REVISED JACKSON HEIGHTS SUBDIVISION

APPLICATION NUMBER 14 DATE July 10, 2008

REQUEST Subdivision

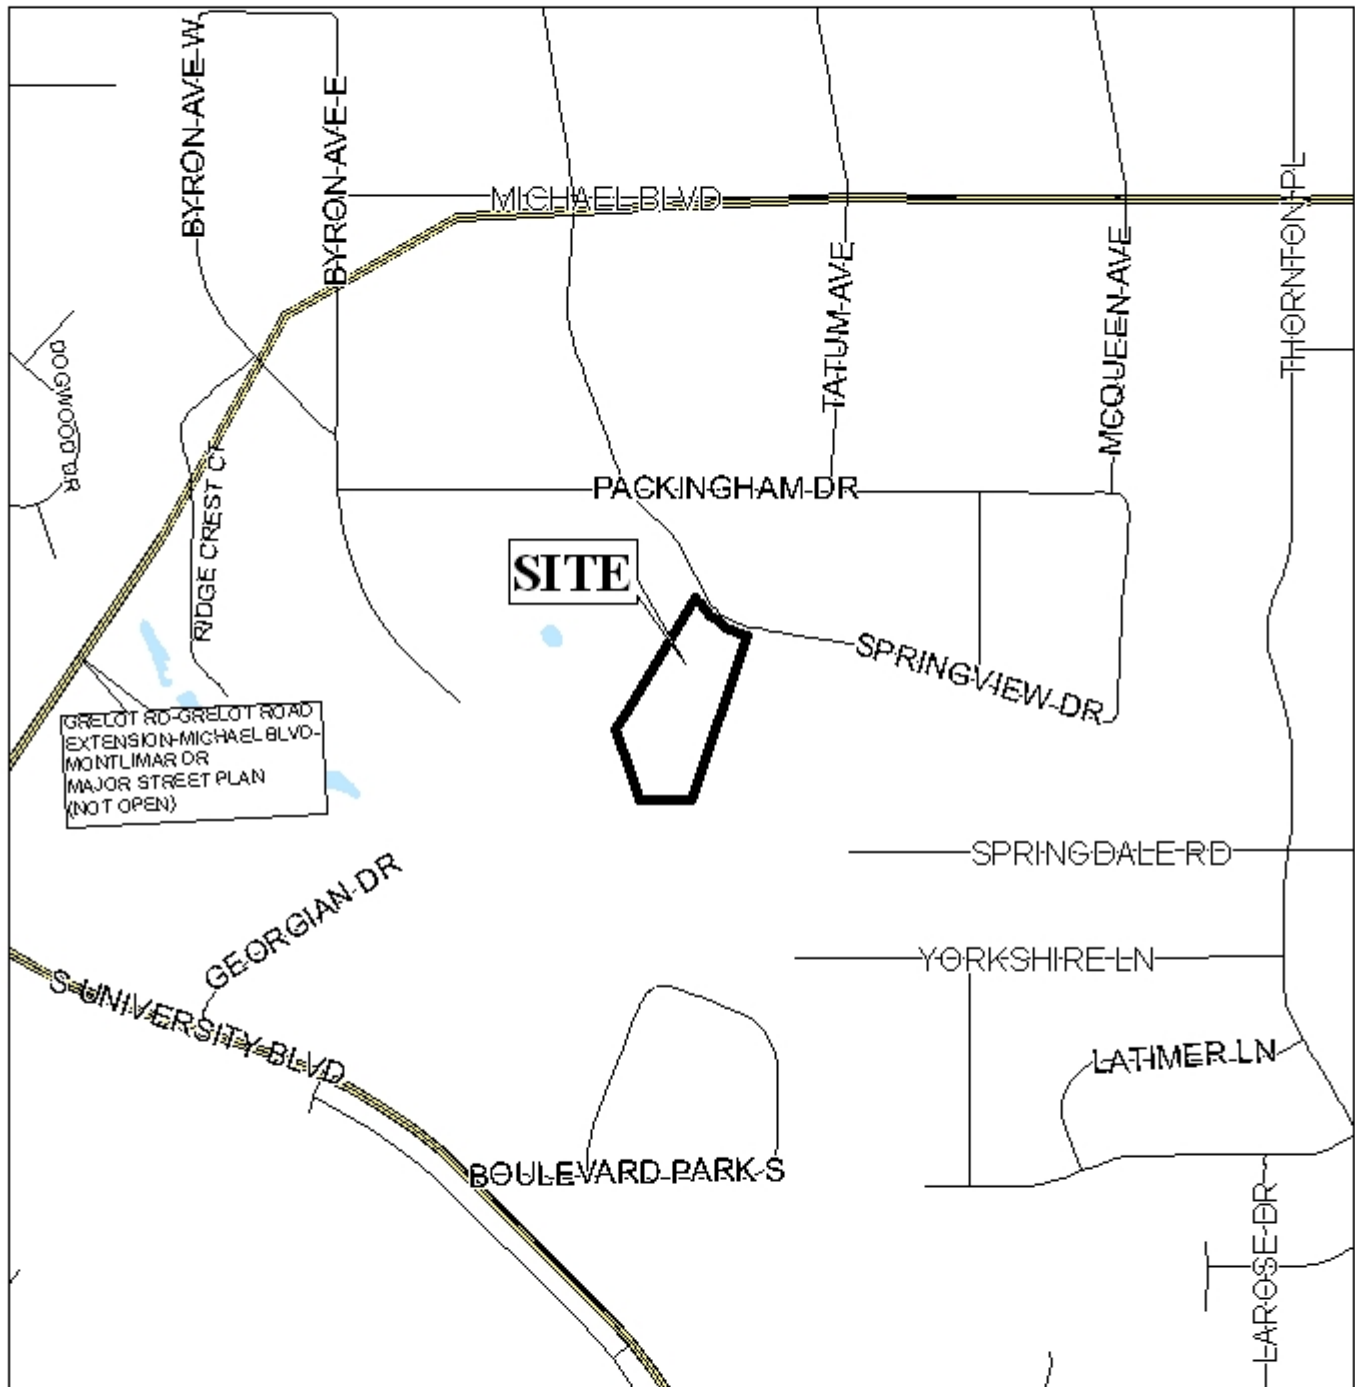
The site fronts Springview Drive, a minor street with 50' of right-of-way. It does not appear that Springview Drive has curb and gutter and, as such, requires 60' of right-of-way; thus, the plat should be revised to provide a minimum 30' as measured from the centerline of Springview Drive.

As proposed, each lot has approximately 100' of frontage along Springview Drive. As a means of access management, a note should be placed on the final plat stating that each lot is limited to one curb cut to Springview Drive, with the size, location, and design to be approved by Traffic Engineering and conform to AASHTO standards.

As illustrated on the plat, there is an existing home on Lot 1 and tennis court on Lot 2; both are in compliance with the setback requirements of Section 64-3.C.1. of the Zoning Ordinance.

The plat meets the minimum size requirement for developments with access to public water and sewer. However, it is requested that the applicant revise the preliminary plat to label each lot with its size in square feet, or provide a table on the plat with the same information.

The site is within the Dog River Watershed and it appears that wetlands exist on a portion of the site. The presence of wetlands and floodplains on the site indicate that the area may be environmentally sensitive; therefore, the approval of all applicable federal, state and local environmental agencies would be required prior to the issuance of any permits or land disturbance activities.

Based on the preceding, the plat meets the minimum requirements of the Subdivision Regulations and is recommended for Tentative Approval, subject to the following conditions:

- 1) dedication of a minimum 30' as measured from the centerline of Springview Drive;
- 2) placement of a note on the final plat stating that each lot is limited to one curb cut, with the size, location, and design to be approved by Traffic Engineering and conform to AASHTO standards;

- 3) labeling of each lot with its size in square feet, or the provision of a table on the final plat with the same information;
- 4) the approval of all applicable federal, state and local environmental agencies prior to the issuance of any permits or land disturbance activities;

- 5) placement of a note on the plat / site plan stating that the site must be developed in compliance with all local, state and Federal regulations regarding endangered, threatened or otherwise protected species; and
